Gold Standard Design Certification Report

**“N’Situ Pelende by Colruyt Group”
(GS12214)**

Report No: CCIPL1876/EU-GS/20230428

Report Date: 14/08/2024

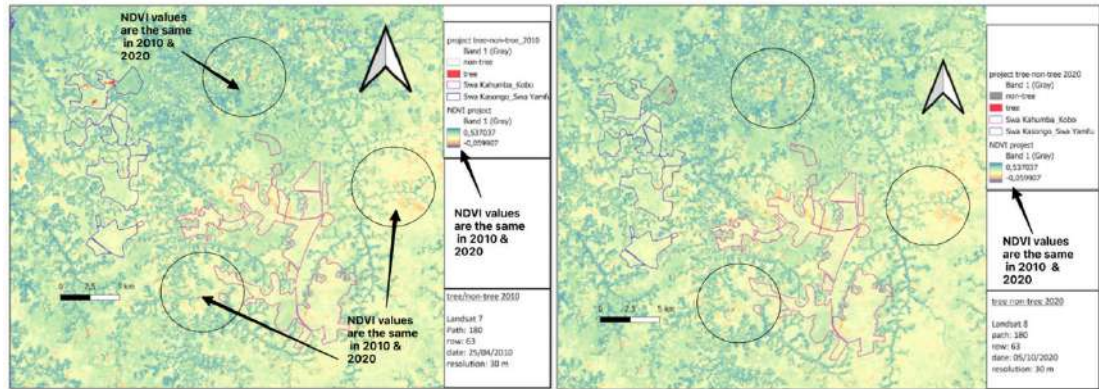
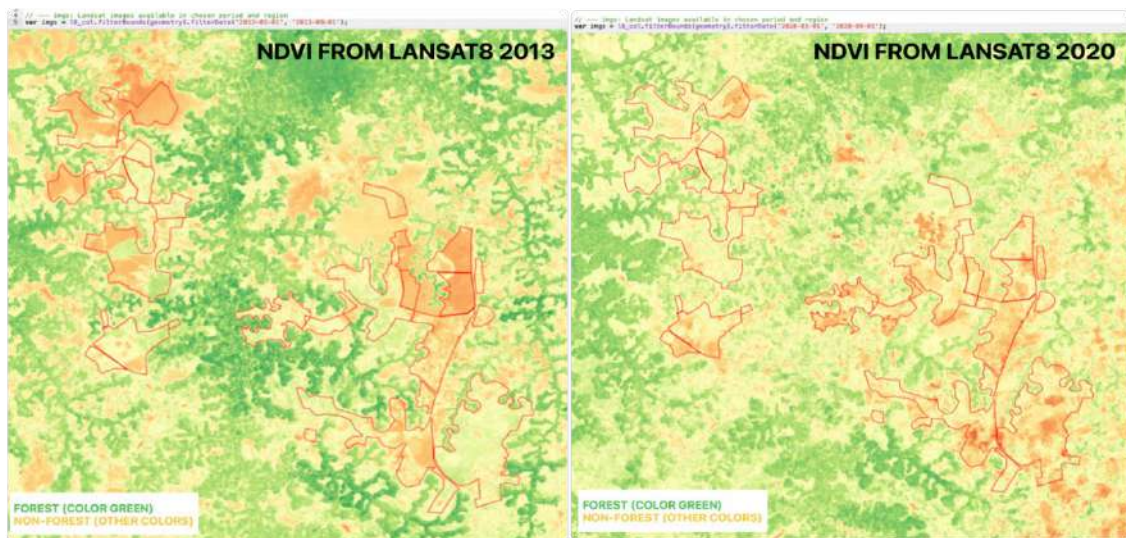
CAR	04	Section no.	Shapefiles	Date: 06/02/2024
Description of CL				
<ol style="list-style-type: none"> Section 4.1.3. of the <i>GS4GG AR_LUF-Activity-Requirements</i> mentions a list of vector shapefiles that are required to be submitted. PD is also requested to submit the Conservation area shapefile in compliance with section 3.1.5 of <i>GS4GG LUF Activity Requirements v1.2.1</i>. A .tif image of the eligible area boundary has been provided by the PD. As per section 4.1.3 of the <i>GS4GG AR_LUF-Activity-Requirements</i>, the PD is required to provide a vector shapefile instead of a raster tif image. There is also an error in eligible area tif image. By visualizing the project boundary and the eligible area tif image in QGIS, VVB observed that the eligible area boundary was larger than the project boundary shapefile. PD is requested to provide a vector shapefile of the eligible area boundary and fix any boundary errors.

Eligible area tif image covers a larger boundary than the Project boundary shapefiles provided.				
<ol style="list-style-type: none"> <i>The Forest and non-Forest analysis presented in PDD section A.1.1 the Figure 1 & 2 not evidenced a difference between NDVI 2010 from Landsat 7 & NDVI 2020 from Landsat 8, In the figure below is possible to verify that both NDVI are the same, despite that NDVI are from different year and sensor.</i>

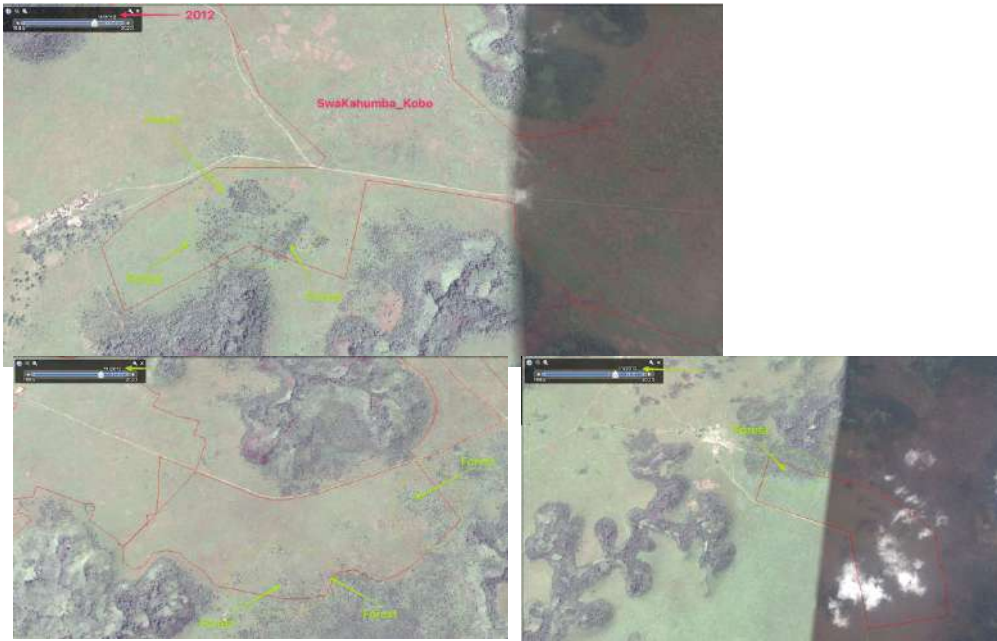
4. Please see for your reference the figure below evidenced the difference between NDVI 2013 vs 2020 for the project area, the colour green represents forest and other colour represent non-forest and both NDVI change in the time as response of the vegetation

change.
